**ADDENDUM
NO. 01**

July 31, 2024

Renovation of Fall Creek Intermediate School
12011 Olio Road
Fishers, IN 46038

DRAWING NO.
M4-3

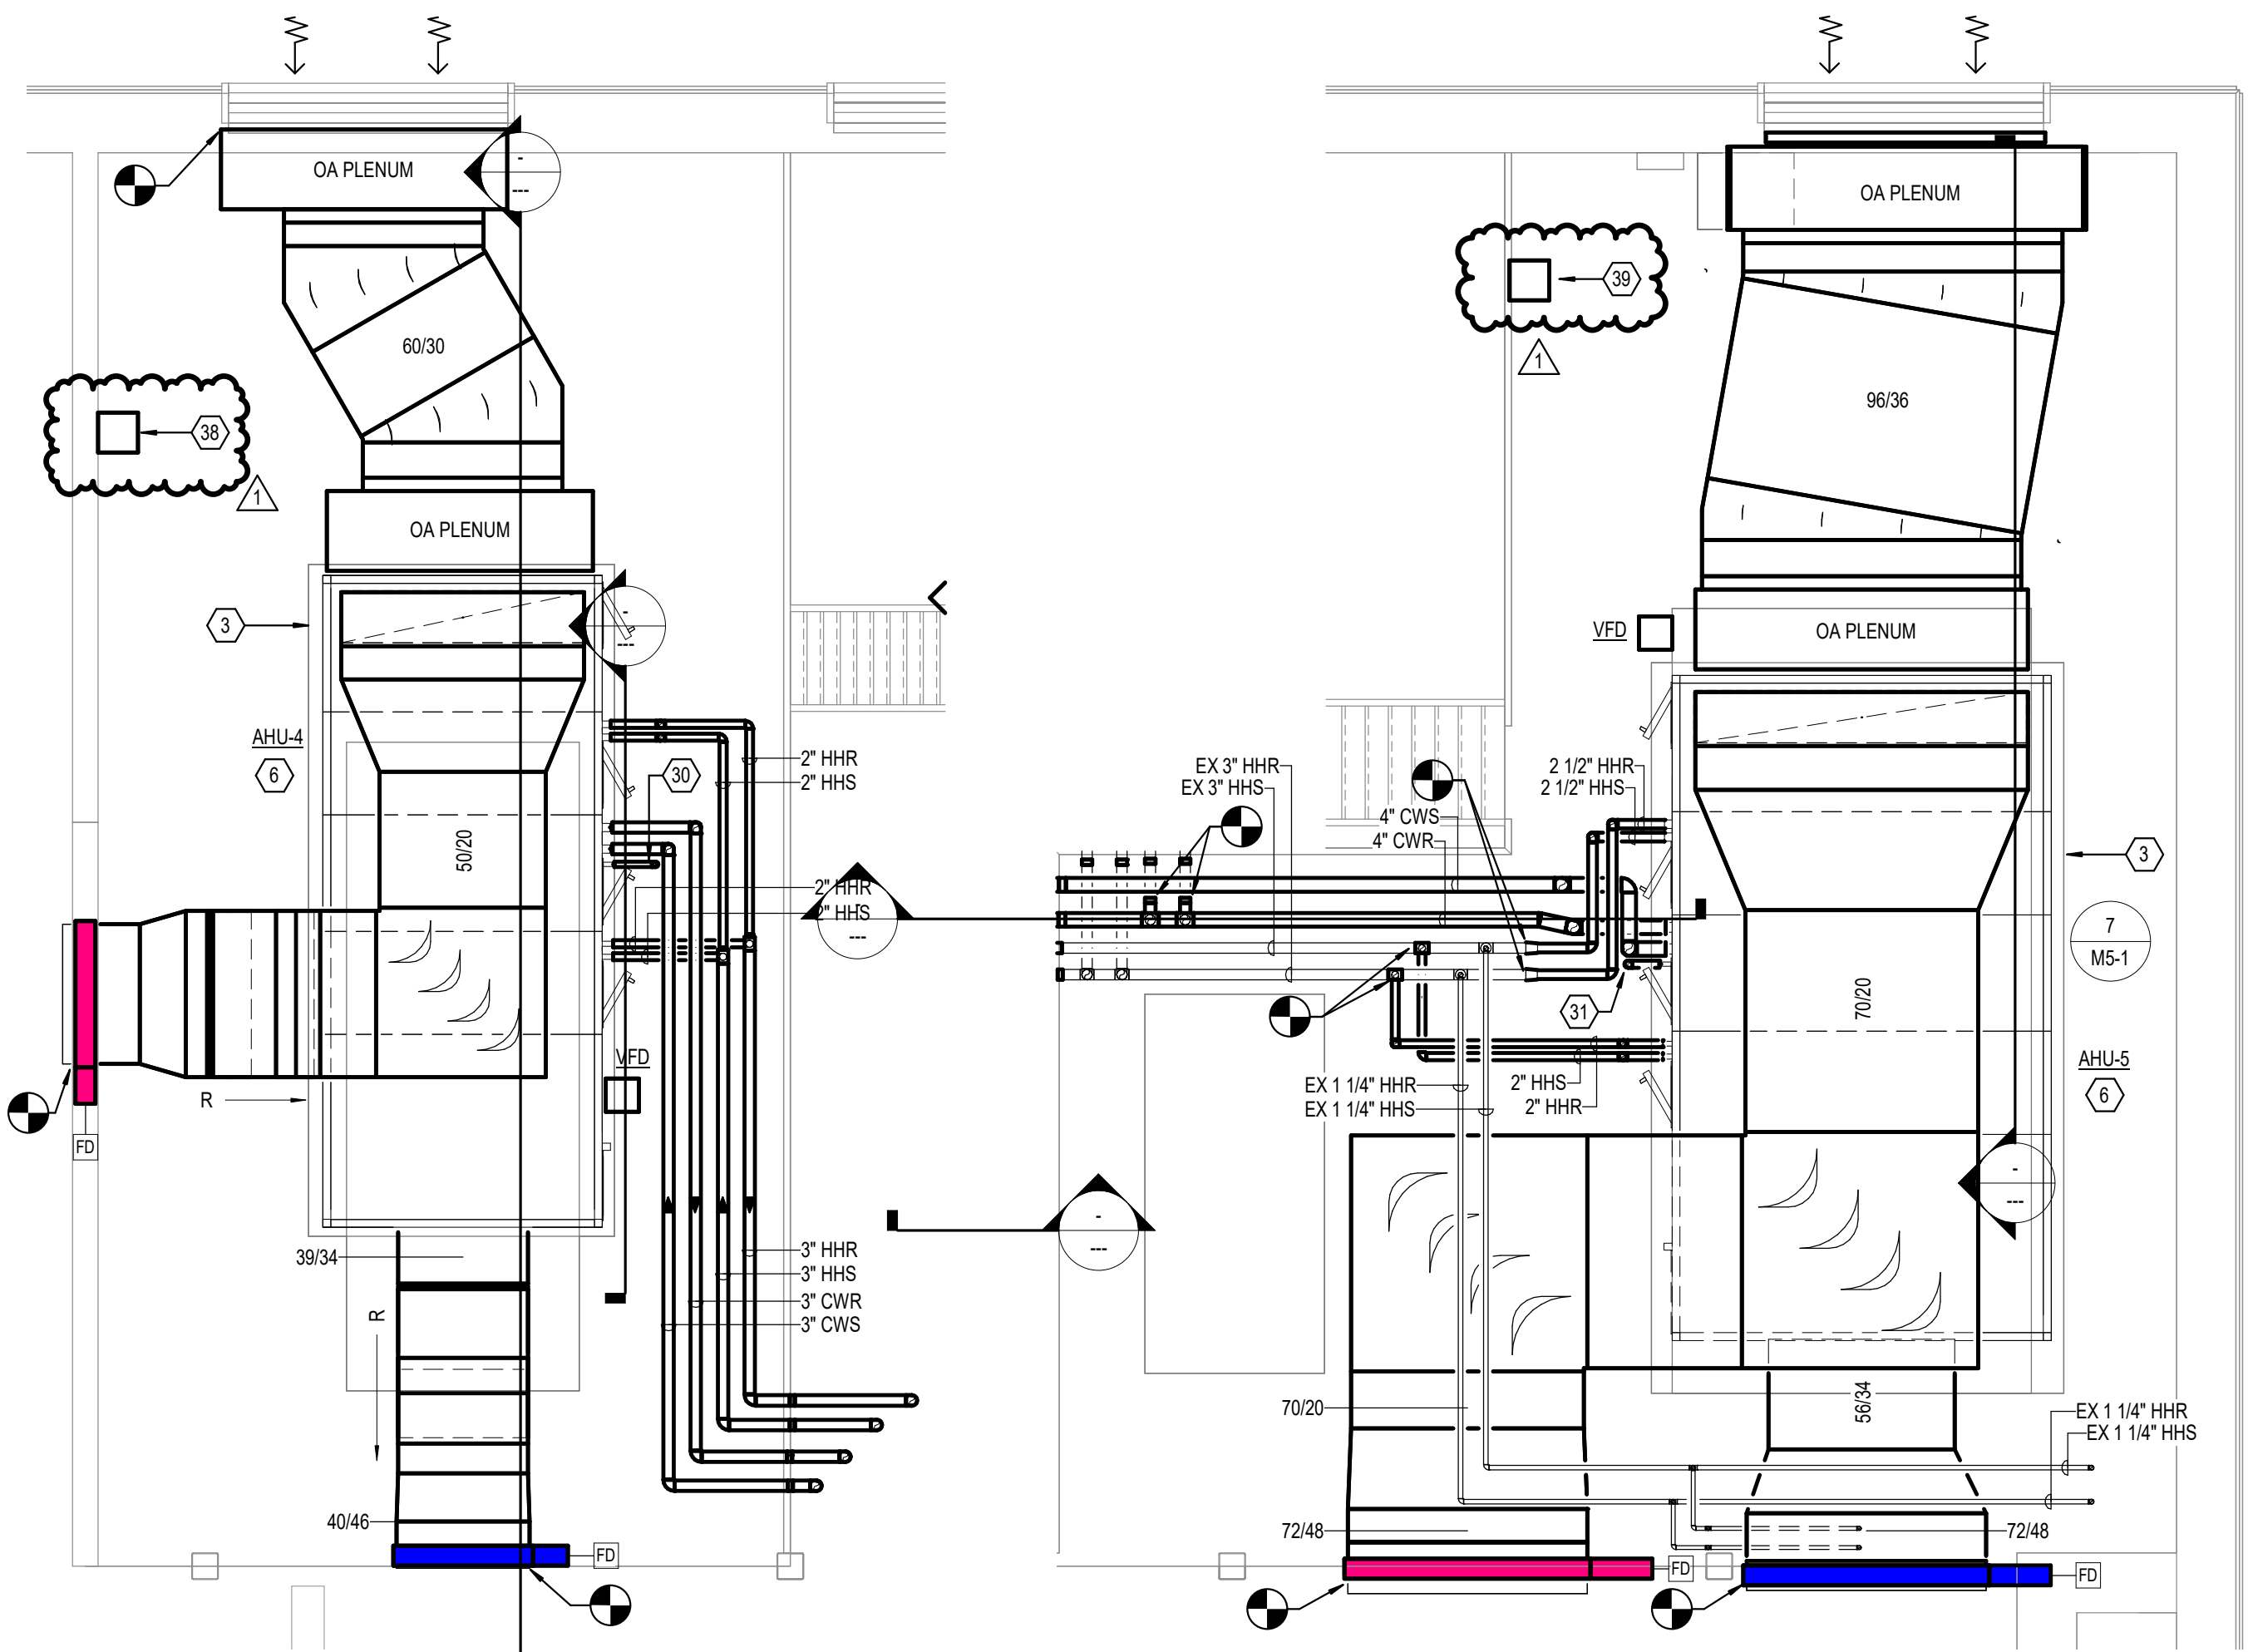
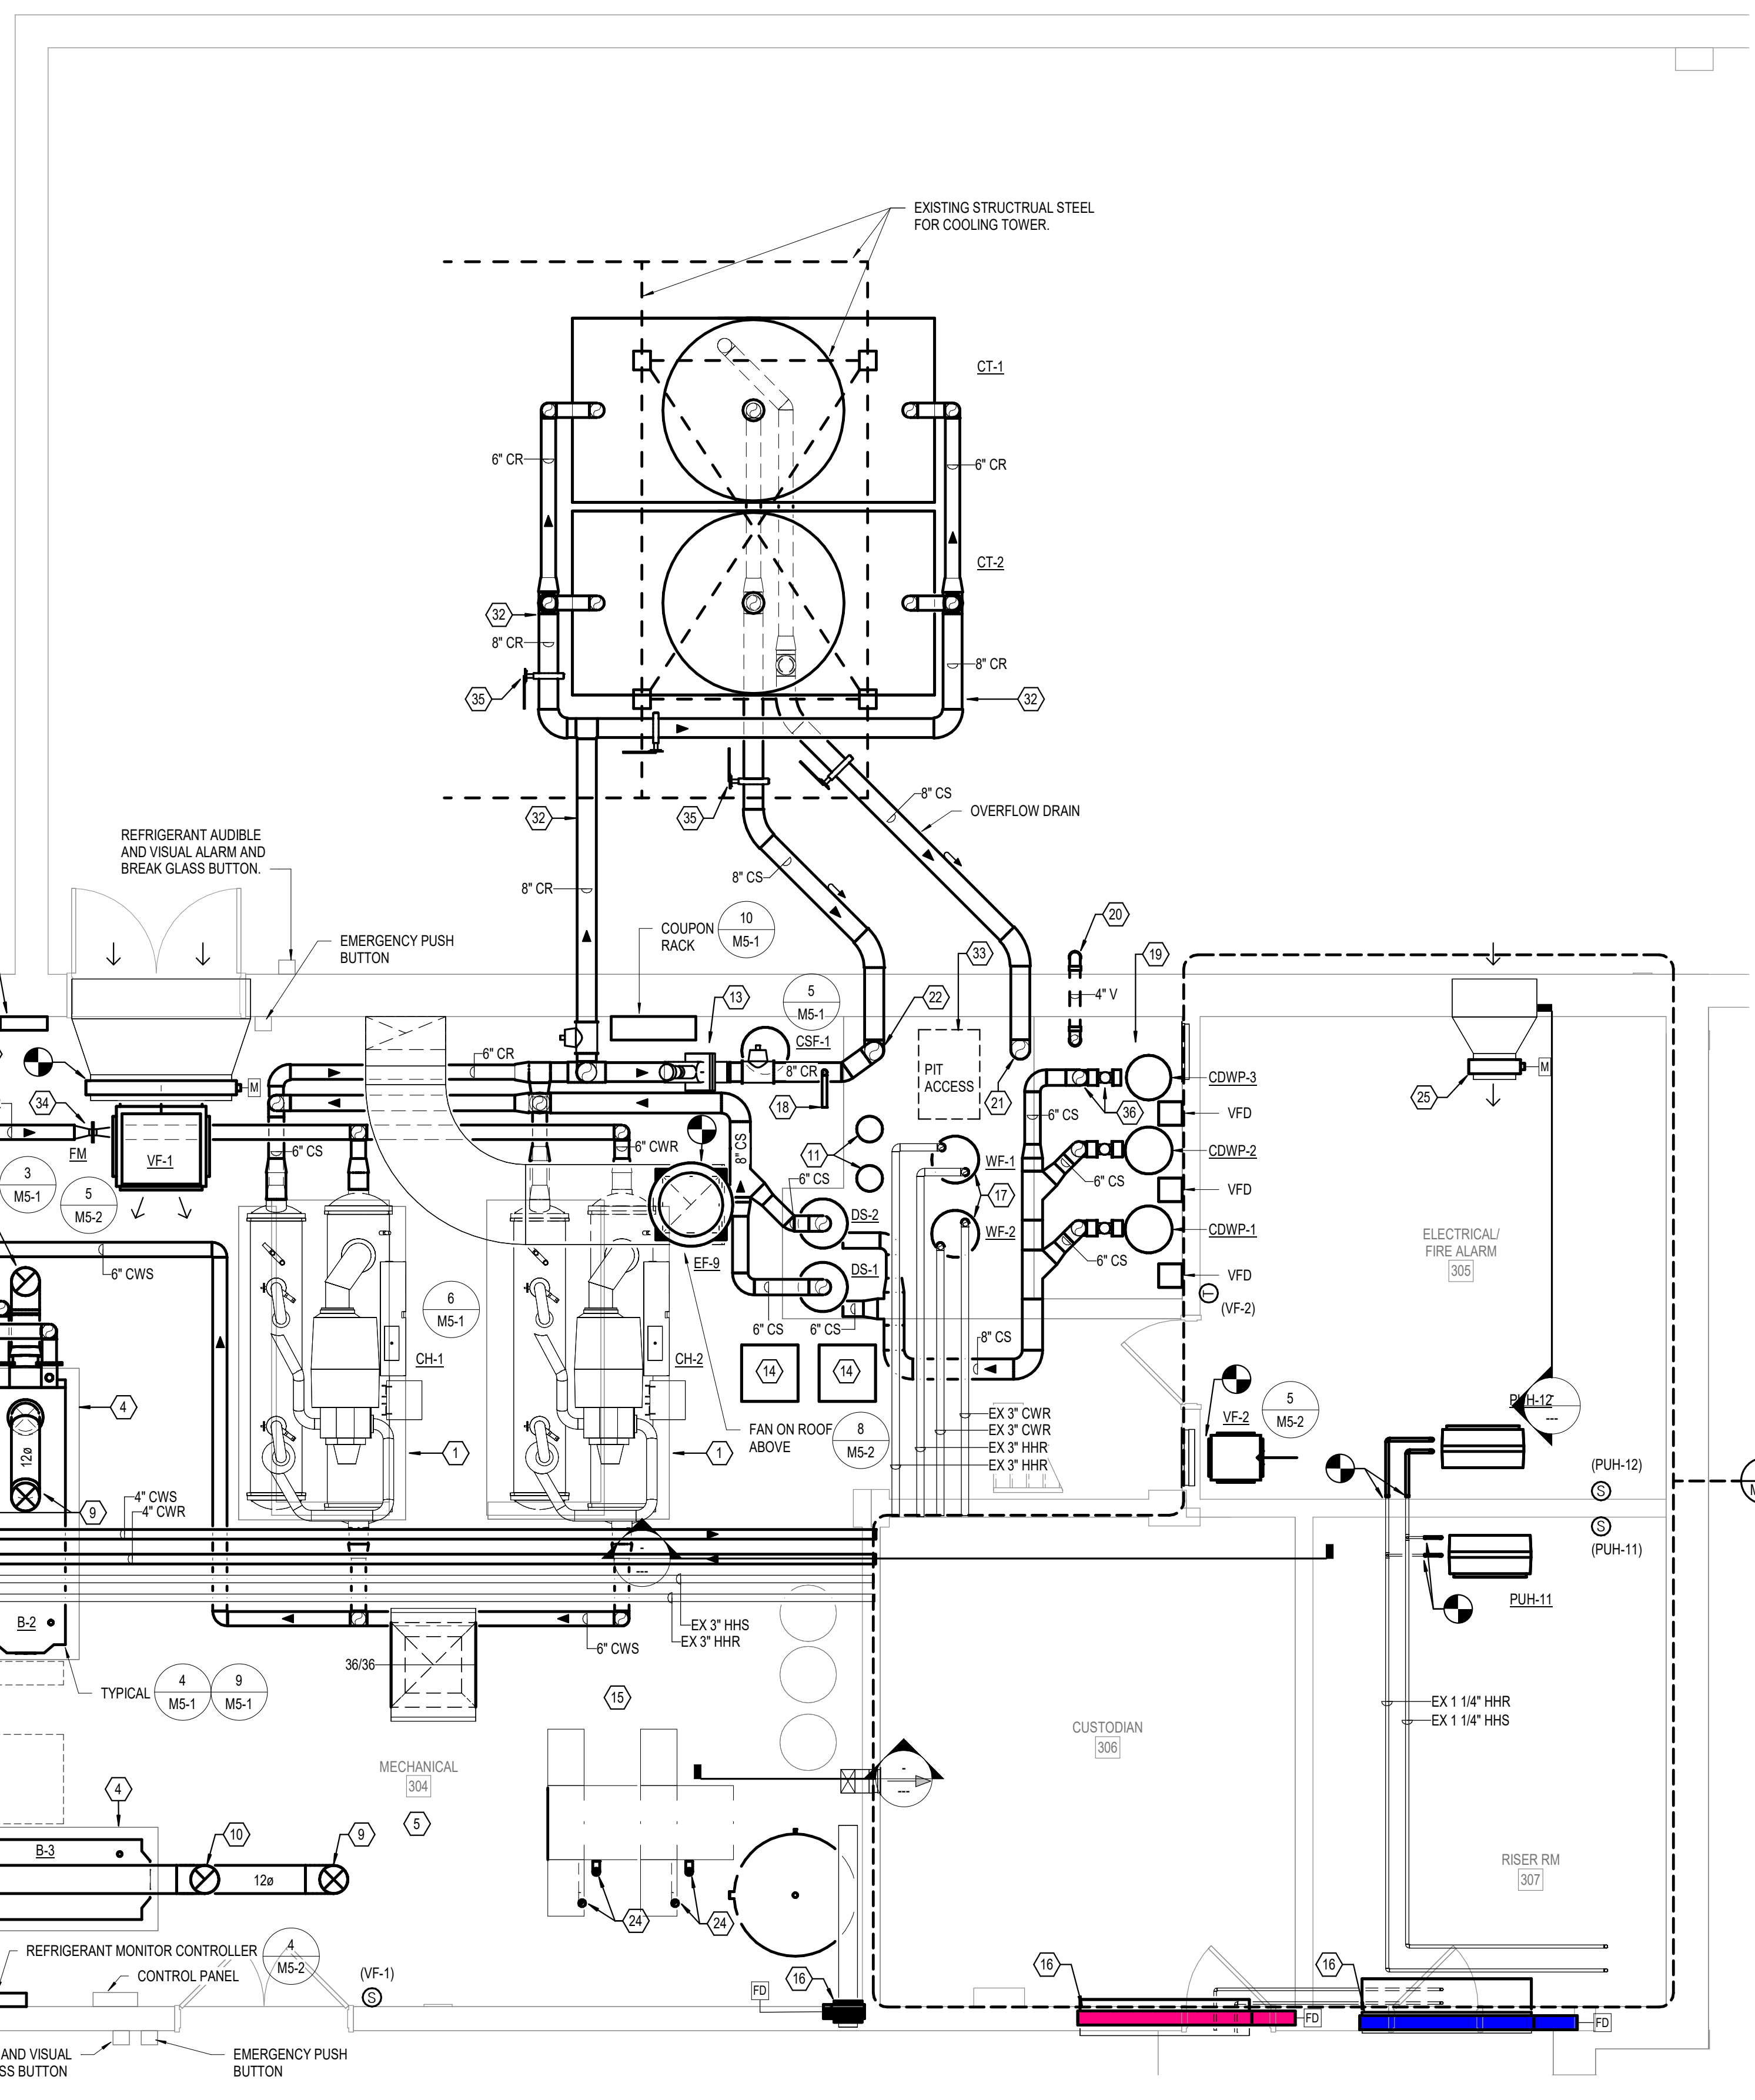
Sheet M4-3 ENLARGED MECHANICAL PLANS

1. Added plan note #37, 38 & 39.
2. Added low voltage controls transformers.
